SUBJECT: Elevator Torque Tube Assembly welds

© STODDARD-HAMILTON AIRCRAFT, INCORPORATED				
MODEL	ASSEMBLY NAME	REVISION	DATE	PAGE
GLASAIR	SERVICE BULLETIN 140		11/30/95	1 of 1

FIGURE 1

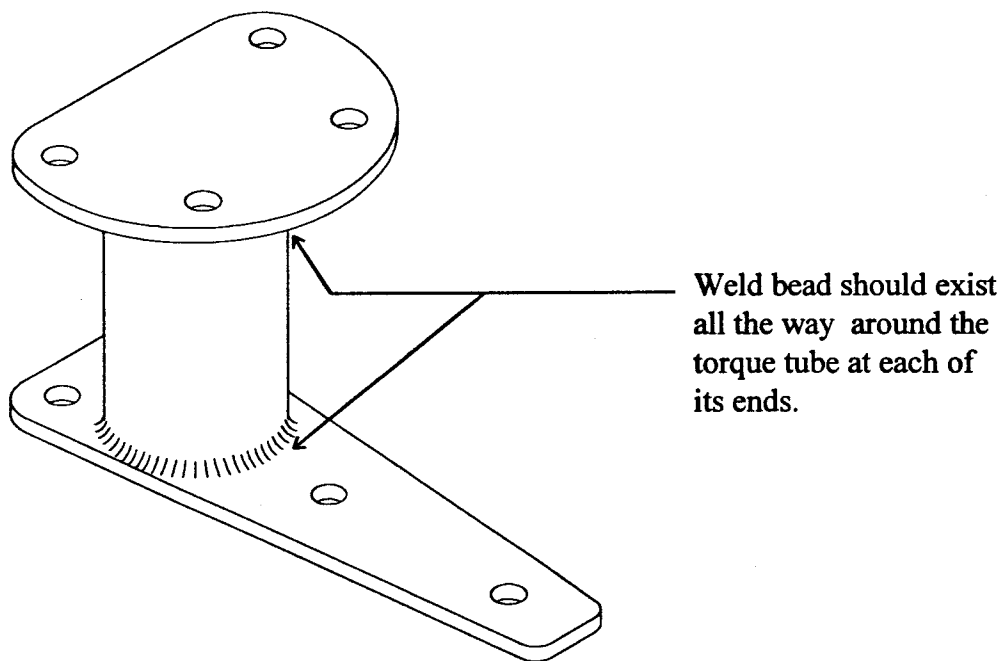
DESCRIPTION: It has come to our attention that some elevator torque tubes may have been shipped without being completely welded. A weld bead should exist all the way around the torque tube at each of its ends as shown.

REQUIRED ACTION: Visually inspect the Elevator Torque Tube Assemblies (472-3410-101) for complete welds per Figure 1. If an improperly welded torque tube is found, contact Stoddard-Hamilton for a return authorization and replacements of the subject part.
